ADDENDUM NO. 2

RIDGWAY FIRE STATION LOT 26-B1 RIDGWAY, CO 81432

June 10, 2014

This Addendum is issued to inform the Bidders of Revisions and Clarifications to the Bid Documents. This Addendum forms part of the Contract Documents and modifies the original Project Manual and Bid Drawing Set dated May 9, 2014 and issued as "Ridgway Fire Station, Issue A Bid Documents". This Addendum consists of (28) 8-1/2 x 11 typed pages and (7) 24 x 36 drawings.

MAIN LEVEL
CEILING PLAN

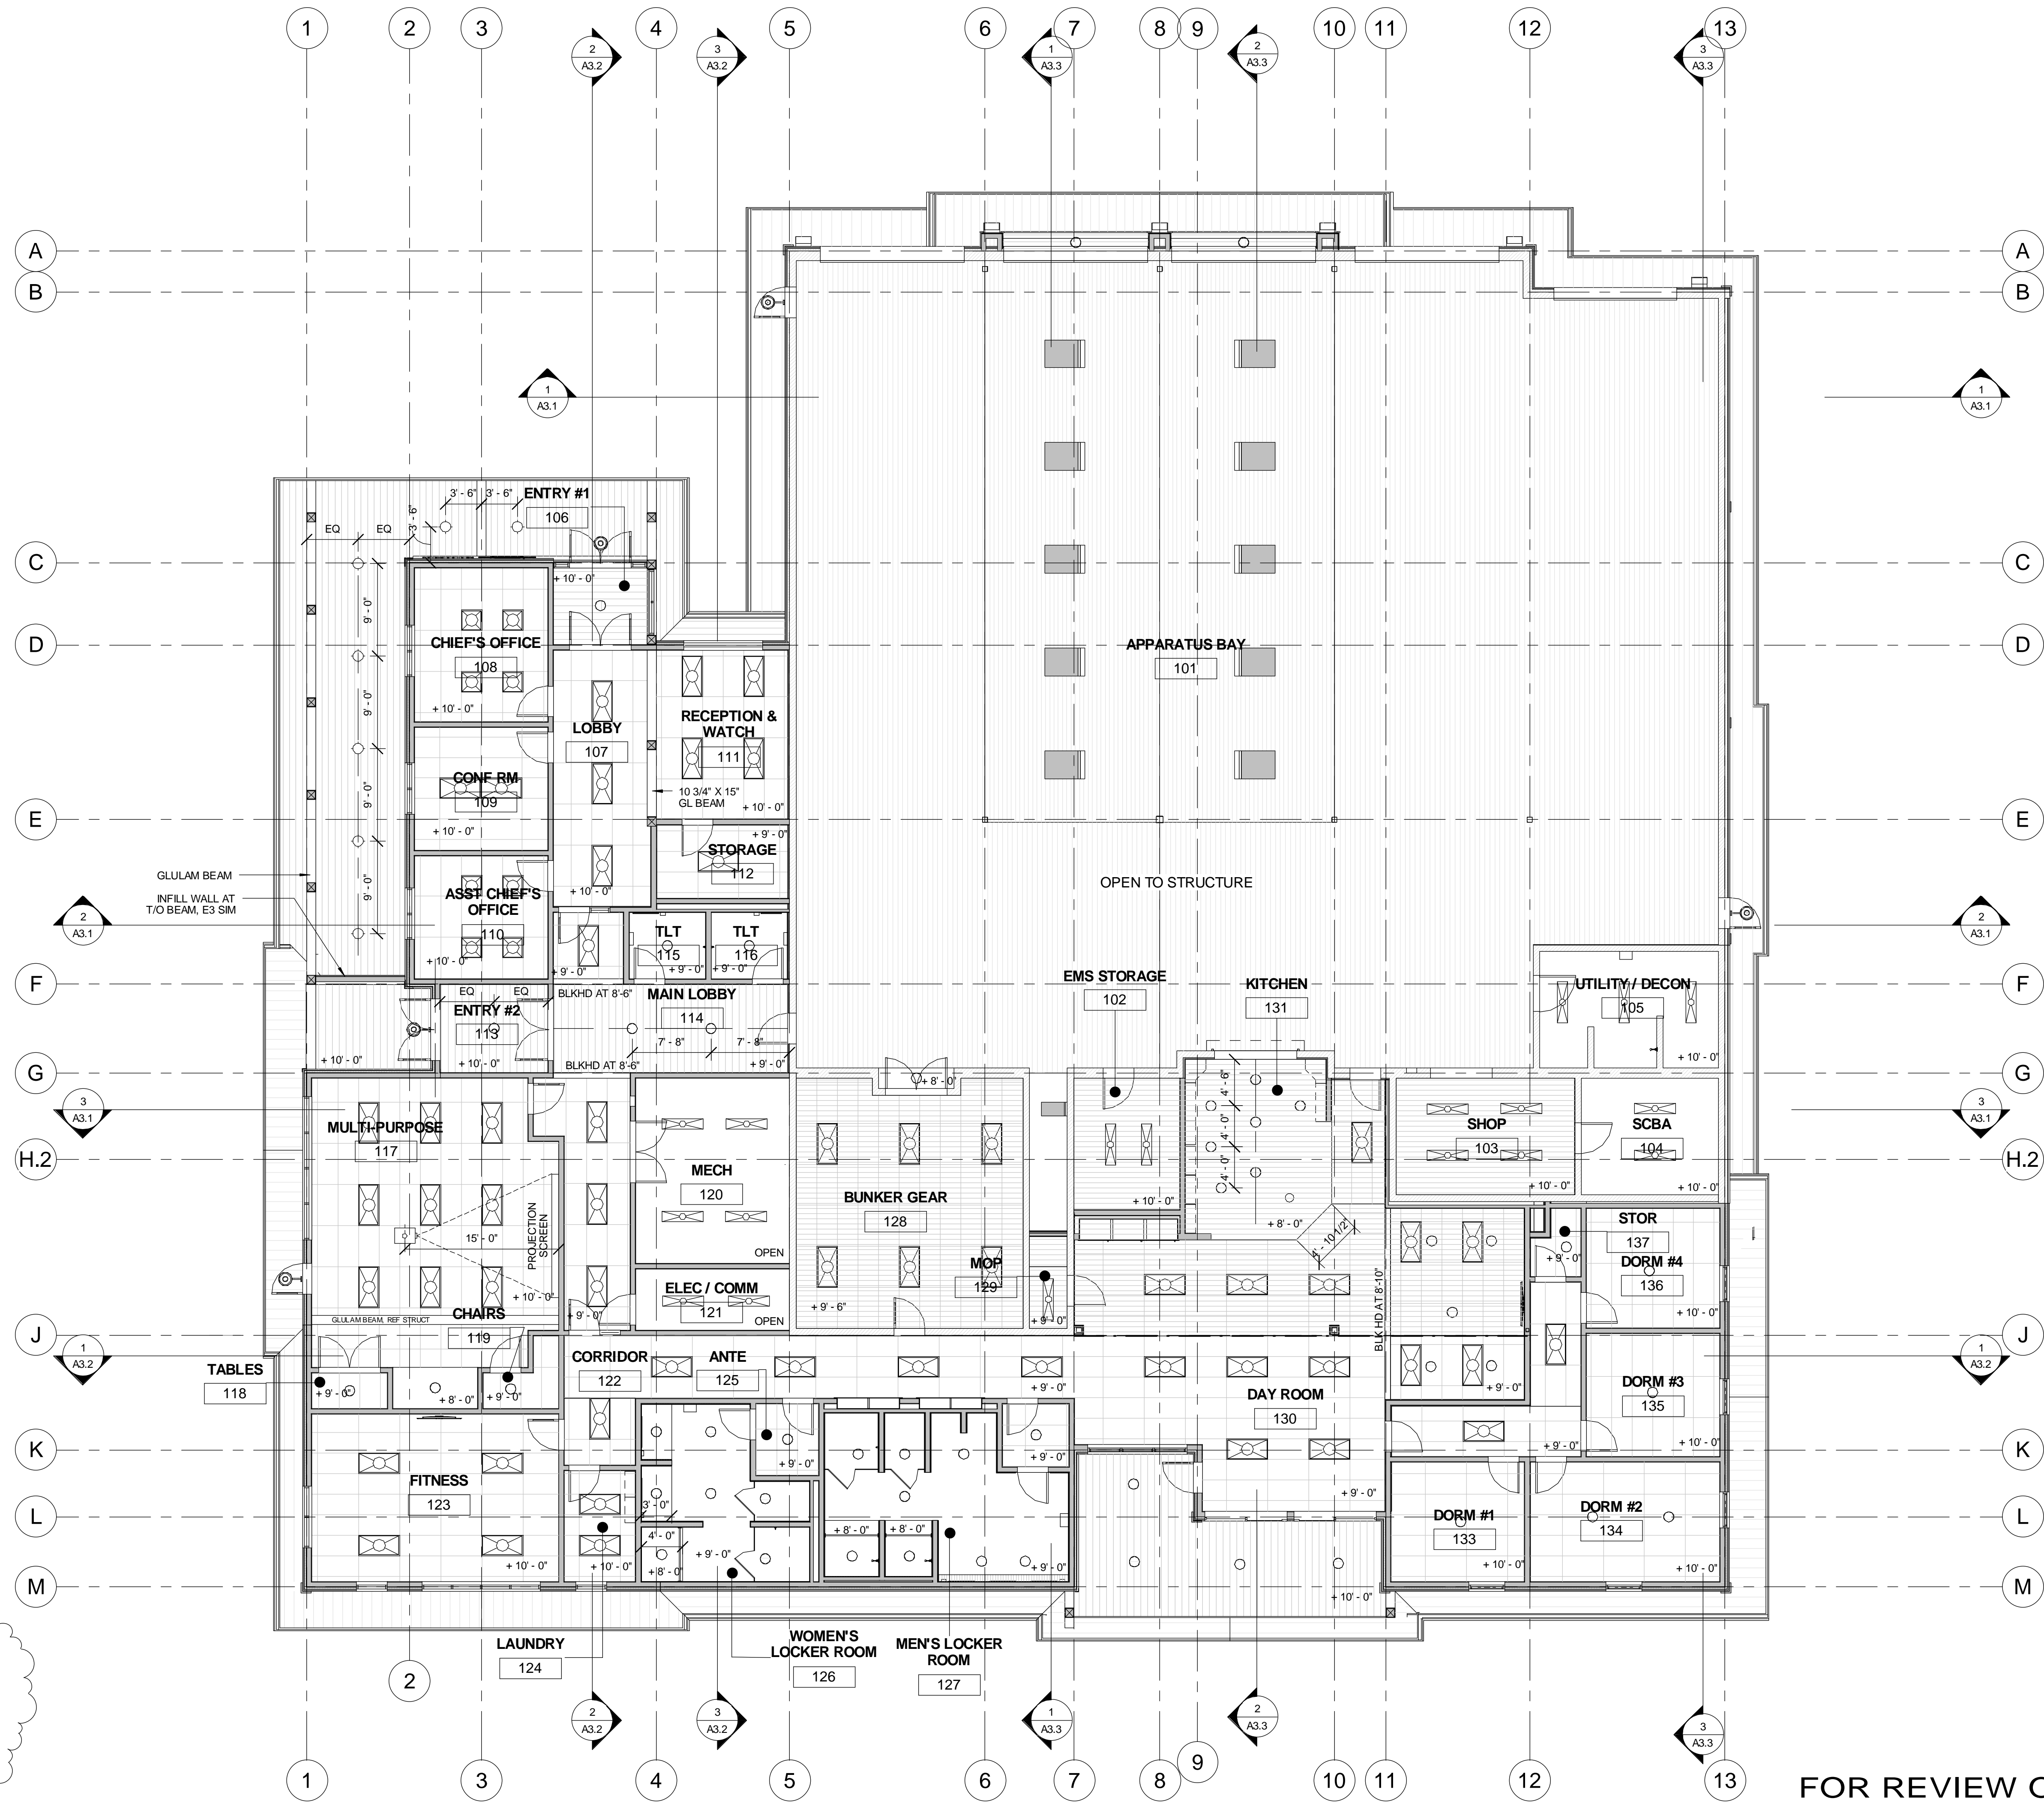
- 2.12 On Sheet A4.1, it is unclear between Grids 1 to 2 and Grids B to G as to where the wood T&G soffit starts and ends.

- 2.13 There is a "striping" pattern for the soffit at the steel framing part of the building and at the wood framing part. Please confirm both get the same metal soffit as depicted on A5.3.

- 2.14 On the Reflected Ceiling Plan, hatching for the Apparatus Bay is very similar to hatching that is used for Entry #2 and Main Lobby which calls out for T&G. Could you verify that the Apparatus Bay is a complete Open Structure with no T&G used in any section of the ceiling space?

- 2.15 Will Type 5/8" Gyp Board be placed above all rooms with acoustical ceiling panels or only above the mezzanine and kitchen?

Response: Ceiling finishes have been clarified on the attached A4.1 Main Level Ceiling Plan.

Response: Ceiling finishes have been clarified on the attached A4.1 Main Level Ceiling Plan.

Response: Ceiling finishes have been clarified on the attached A4.1 Main Level Ceiling Plan.

Response: 5/8" gypsum board will only need to be placed above the acoustic ceiling in areas to receive a 2-hour rated assembly. Ceiling areas to receive a 2-hr rated gyp board ceiling above an acoustic ceiling are indicated on Sheet A4.1 as a hatch pattern. Those rooms include Bunker Gear 128, Mop 129, Kitchen 131, and the north portion of Dayroom 130.

PLUMBING
NOTES AND
SCHEDULES

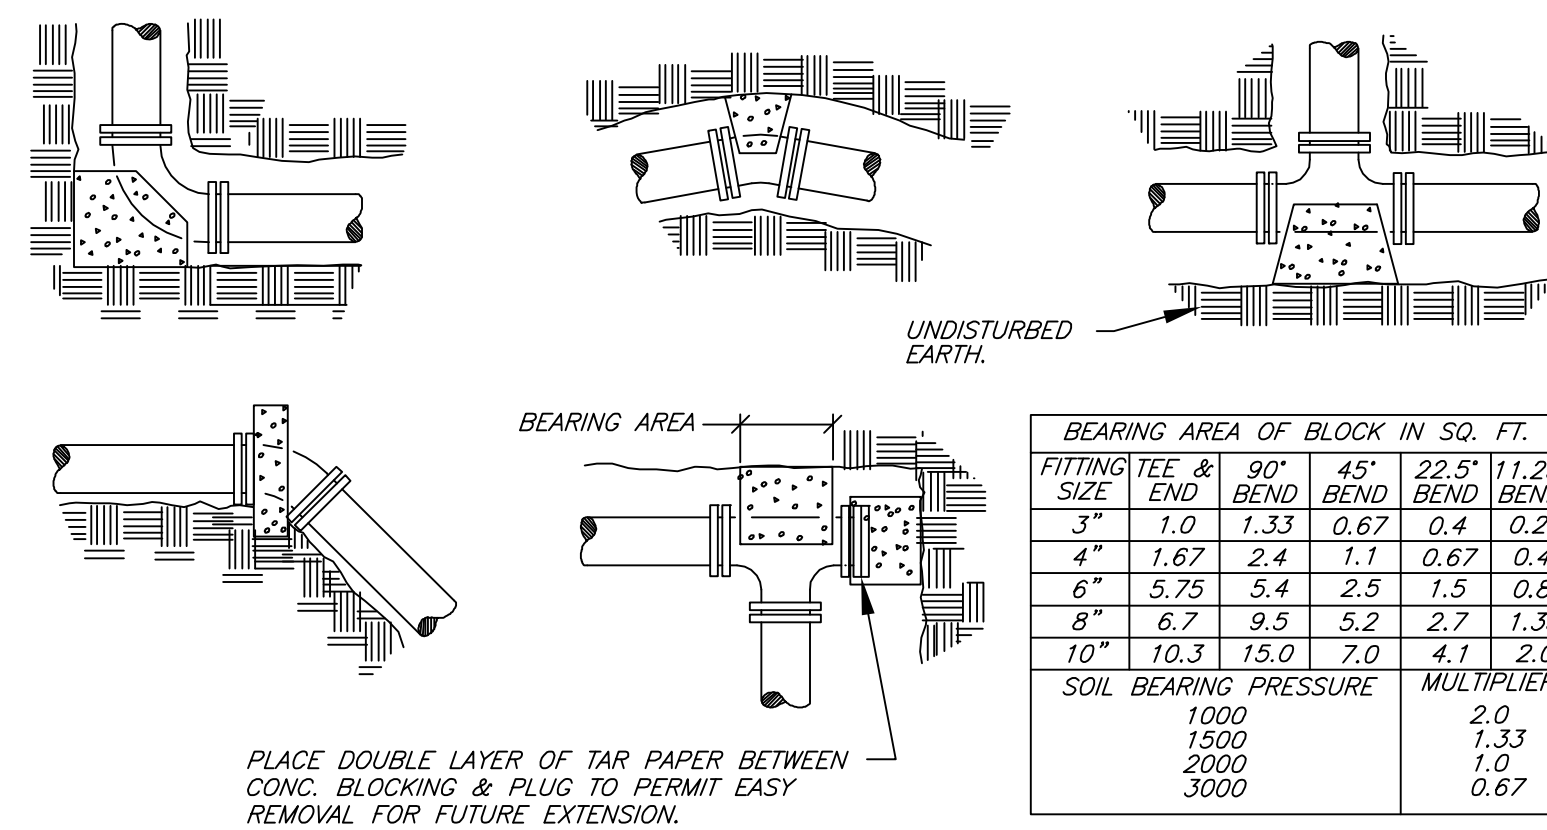
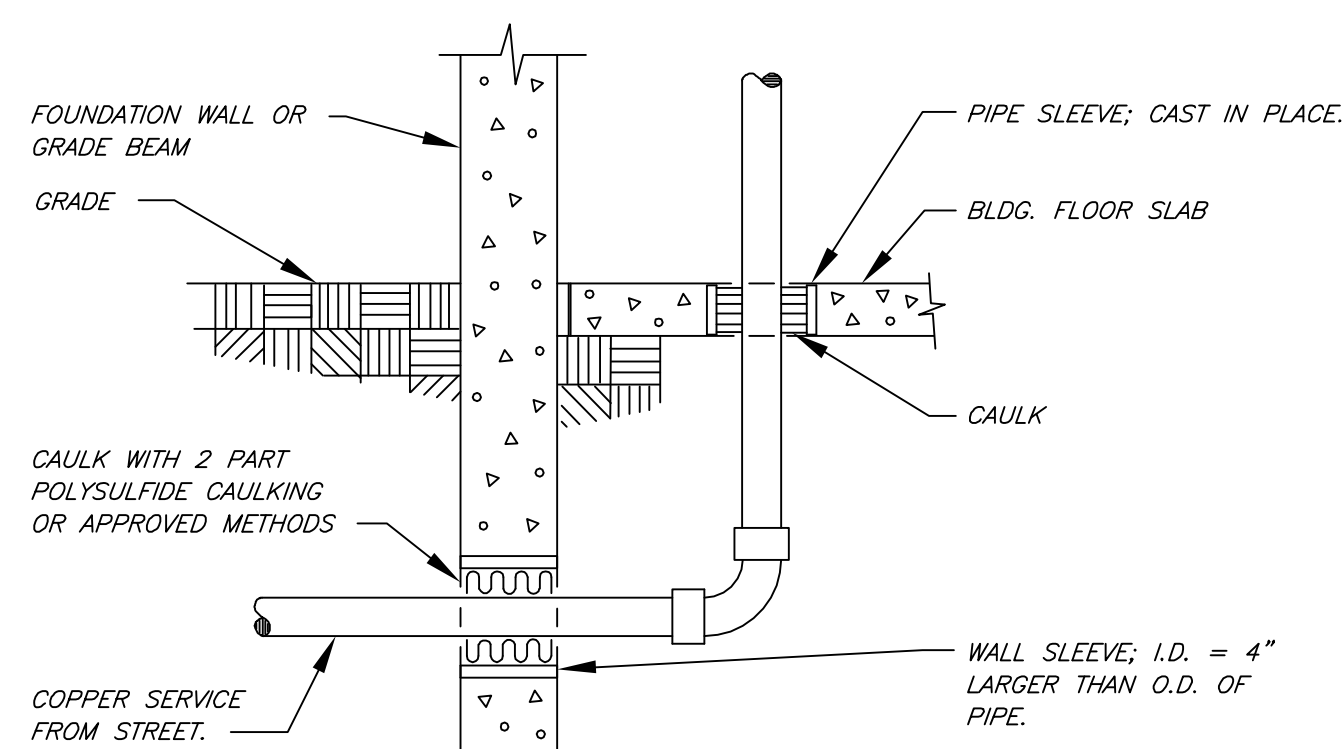
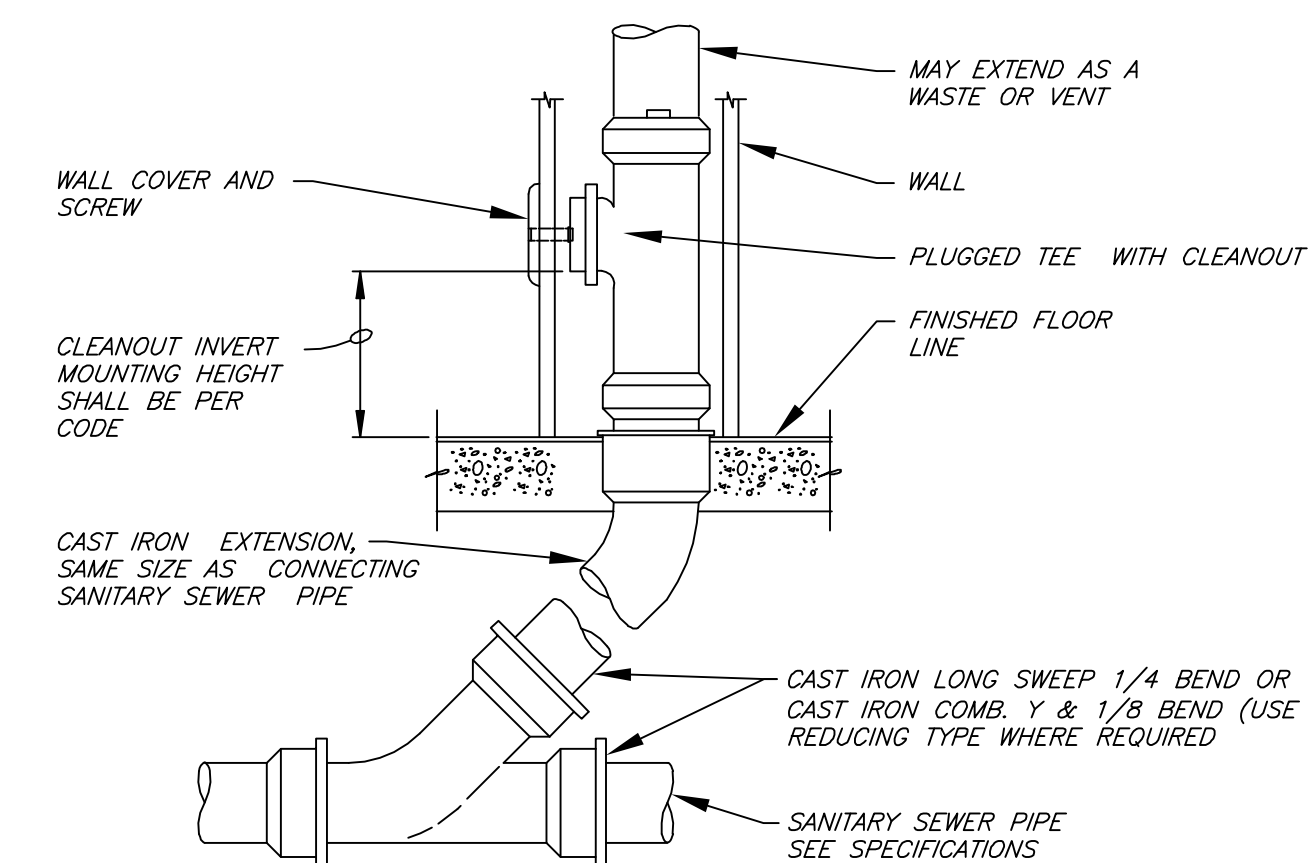
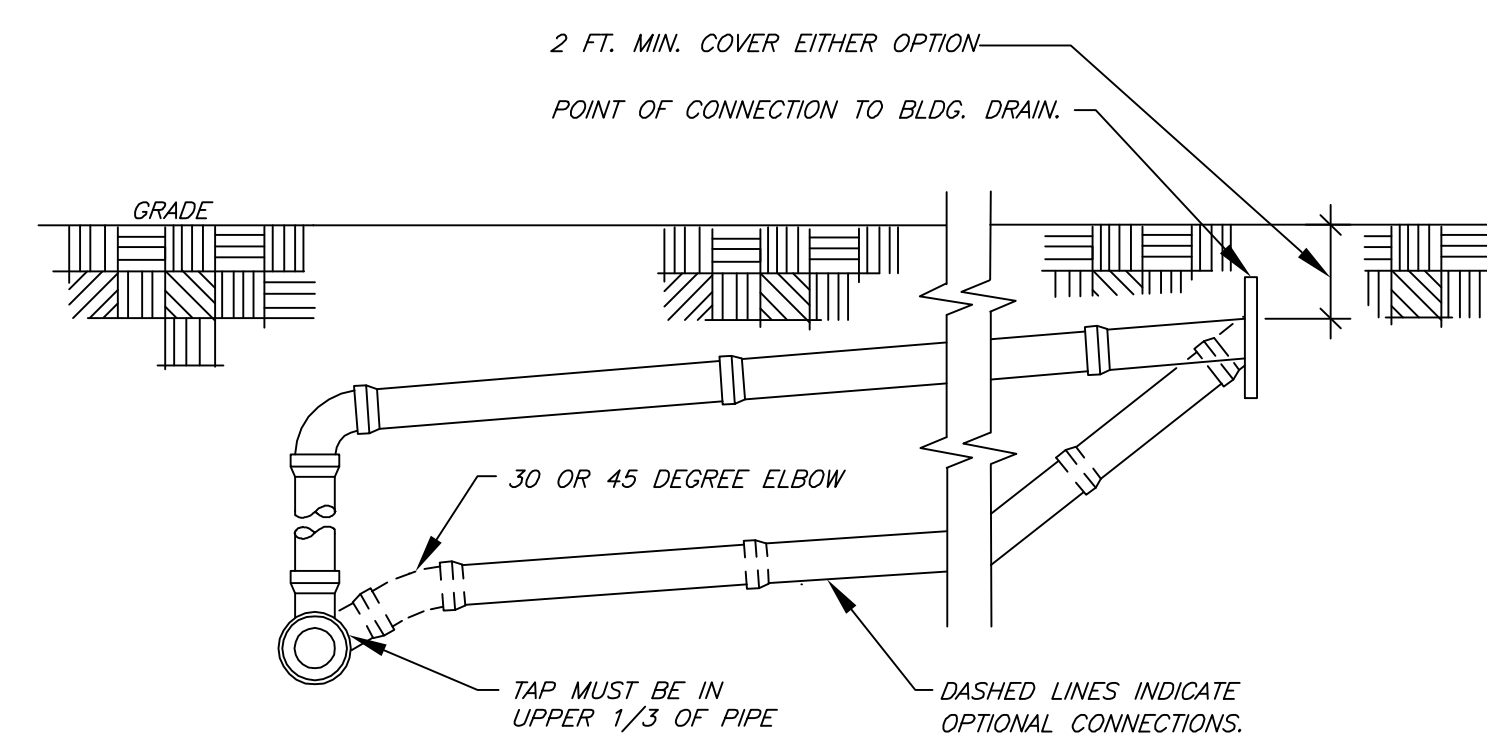
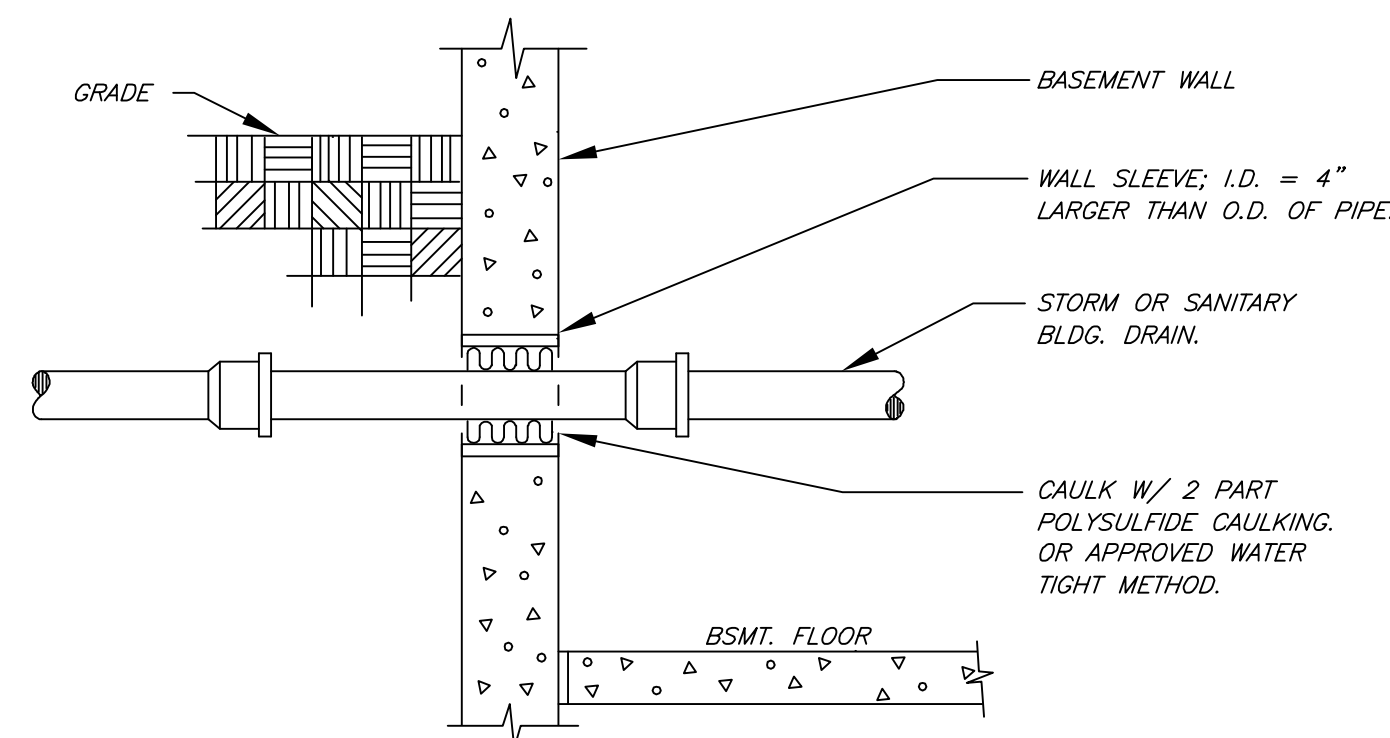
WC-2 changed to WC-1, SH-1, SVH-1, DF-1, S-1, S-3, changed to meet LEED specifications.
